# TDEC for PAM4 ('TDECQ')

Changes to clause 123, to replace TDP with TDECQ

Draft 1a

# Changes to 400GBASE-FR8 and -LR8 (Clause 123)

Figure 123-4 — TDECQ conformance test block diagram

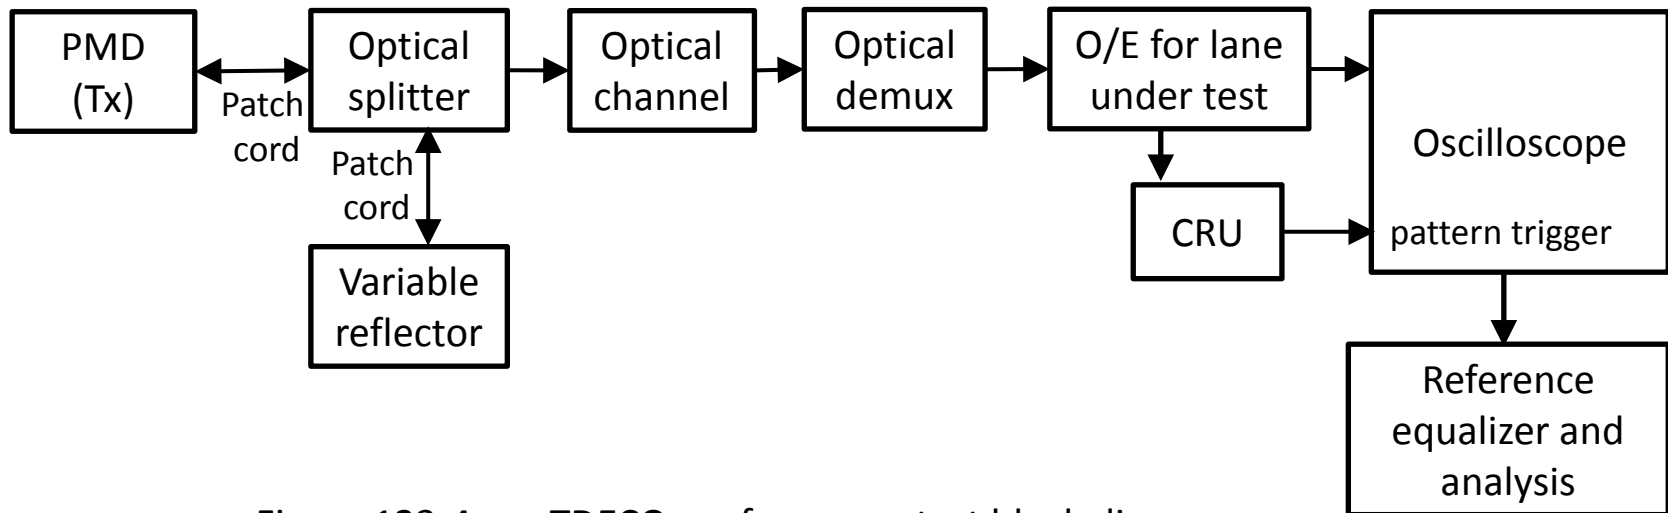
A block diagram for the TDECQ conformance test is shown in Figure 123-4. Other equivalent measurement implementations may be used with suitable calibration.

Each optical lane is tested individually with all other lanes in operation. The optical splitter and variable reflector are adjusted so that each transmitter is tested with the optical return loss specified in Table 123-12. The optical demux is used to separate out the wavelength of the transmitter under test. Each optical lane is tested with the optical channel described in 123.8.5.1. The O/E and the oscilloscope combination has a fourth-order Bessel-Thomson filter response with a bandwidth of 19.34 GHz. Compensation may be made for any deviation from an ideal fourth-order Bessel-Thomson response.

The test pattern (specified in Table 123-11) is transmitted repetitively by the optical lane under test and the oscilloscope is set up to capture the complete pattern for TDECQ analysis as described in 123.8.5.3.

# Figure 123-5 Illustration of the TDECQ measurement

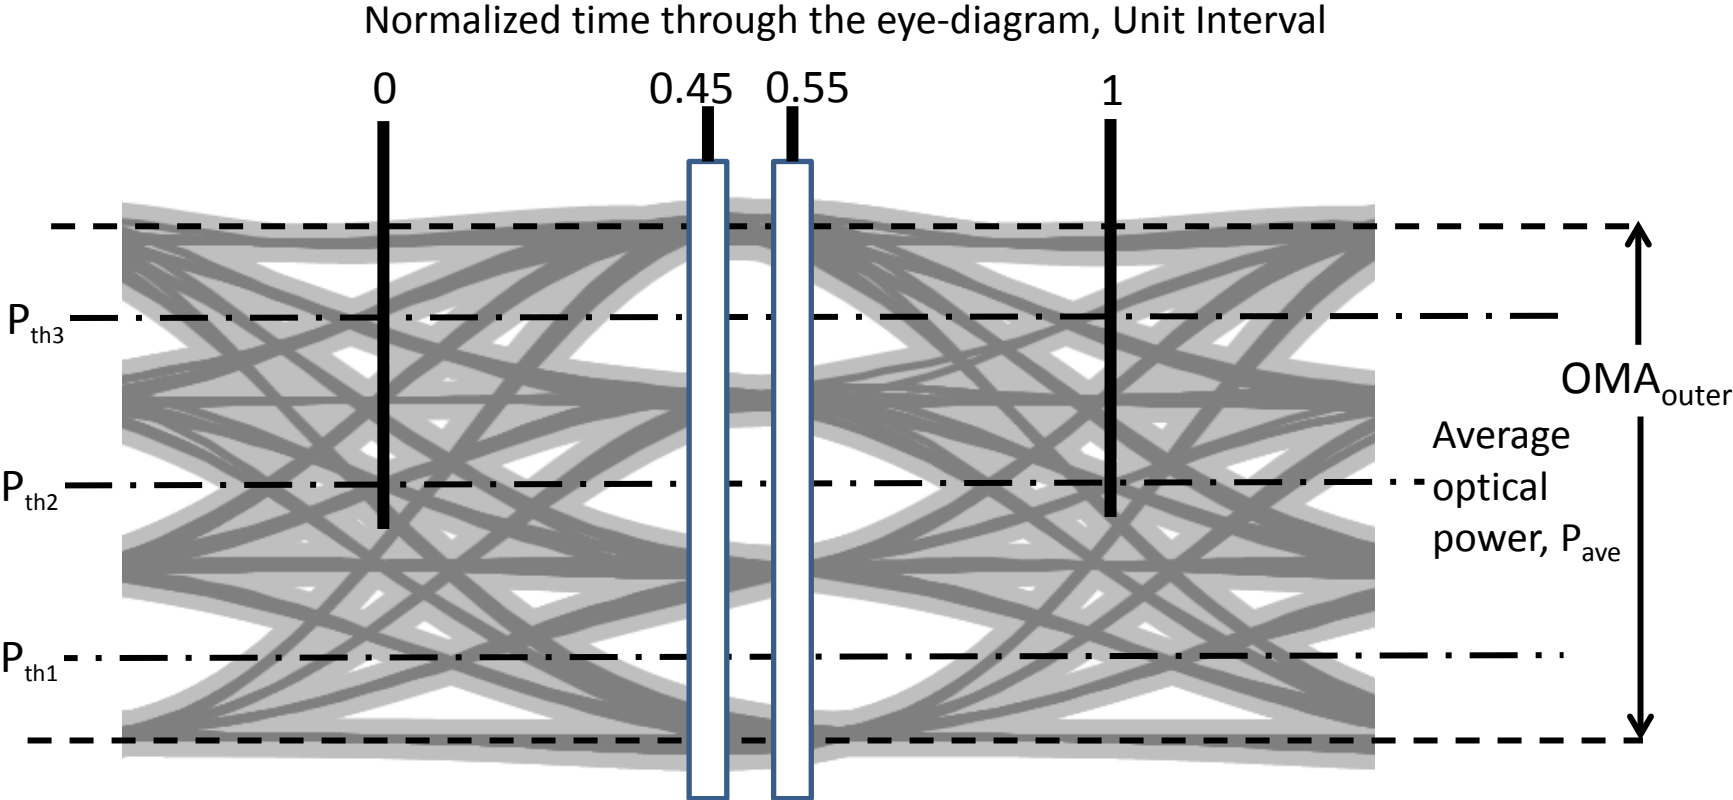
The average optical power ( $P_{ave}$ ) of the eye diagram is determined, and the 0 UI and 1 UI crossing points are determined by the average of the eye diagram crossing times, as measured at  $P_{ave}$ , as illustrated in Figure 123-5.

Two vertical histograms are measured through the eye diagram, centered at 0.45 UI and 0.55 UI, each of the histograms spans all of the modulation levels of the eye diagram, as illustrated in Figure 123-5.

Each histogram window has a width of 0.04 UI. Each histogram window has outer height boundaries which are set beyond the extremes of the eye diagram (so that no further samples would be captured by increasing the vertical separation of the height boundaries).
